APPLICATION NO.	FILING DATE	FIRST NAMED INVENTOR	ATTORNEY DOCKET NO.	CONFIRMATION NO.
10/765,959	01/29/2004	Ralph W. Baxter JR.	8200.709	2328

Office Action Summary

This is a first office action on the merits of patent application S. N. 10/765,959.

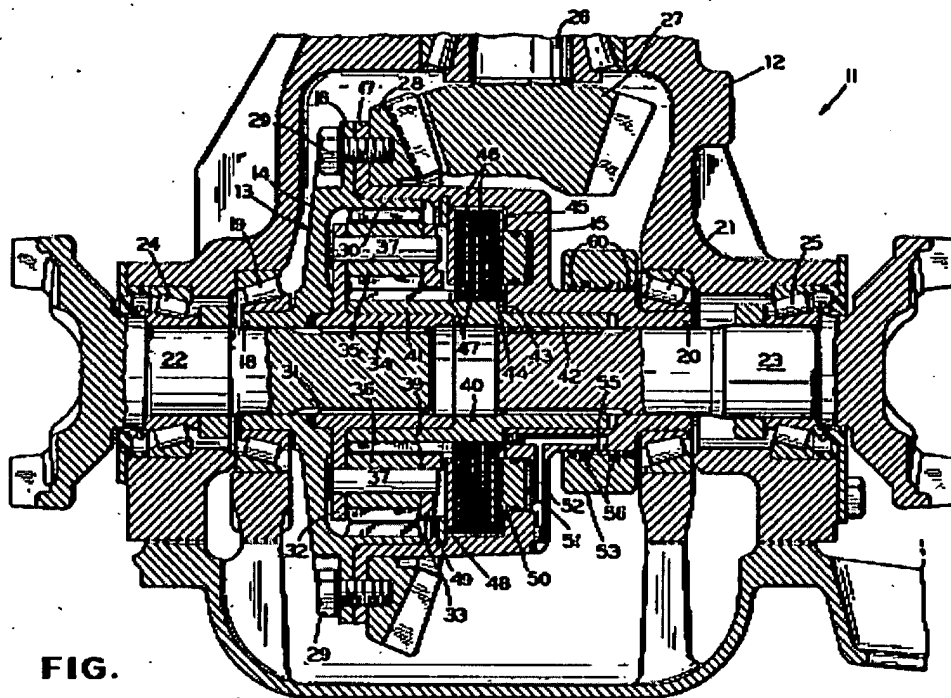
Claims 1-2, 5, 7-8, 14, 16, 19, 21-22 are rejected under 35 U.S.C. 102(b) as being anticipated by Blessing ('634).

Blessing discloses a torque transmission apparatus (Fig. 1), a differential assembly (11), a differential case (13), output shafts (22, 23), a friction clutch (45), a hydraulic clutch actuator (Fig. 3), a hydraulic pump (65), a hydraulic pressure accumulator (69), a housing (12), a drive pinion (27), a directional valve (61), a piston assembly (50), a reservoir (63), a solenoid control valve (71), and an electronic module (Col. 6, lines 33-35).

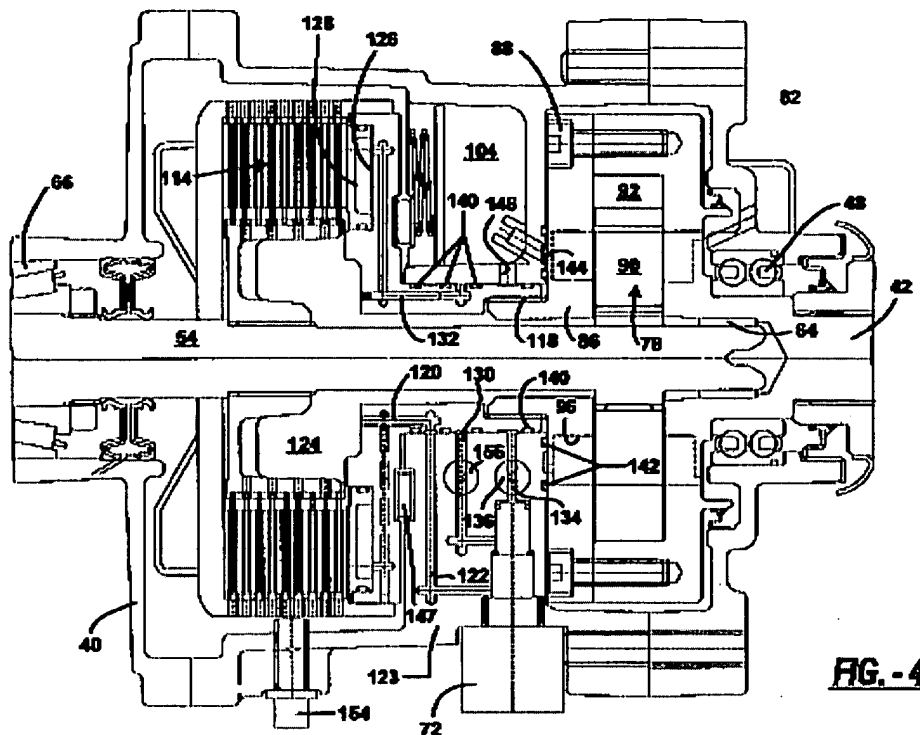
Claims 1-23 are rejected under 35 U.S.C. 102(b) as being anticipated by Porter ('654).

Porter discloses a torque transmission apparatus (Fig. 2), a differential assembly (Fig. 4), a differential case (110), at least one output shaft (54), a friction clutch (114), a hydraulic clutch actuator (Fig. 5), a hydraulic pump (78), a hydraulic pressure accumulator (104), a housing (123), a drive pinion (220), a pinion shaft (54), a directional valve (136), a piston assembly (128), a reservoir (100), a solenoid control valve (72), an electronic module (68), and anti-lock braking system (150A-150D). Since no structure is associated with the recitation of the differential and noting that the device depicted in Fig. 4 allows differential rotation, it should be noted that for rejection purposes the coupling shown in Fig. 4 is considered a differential.
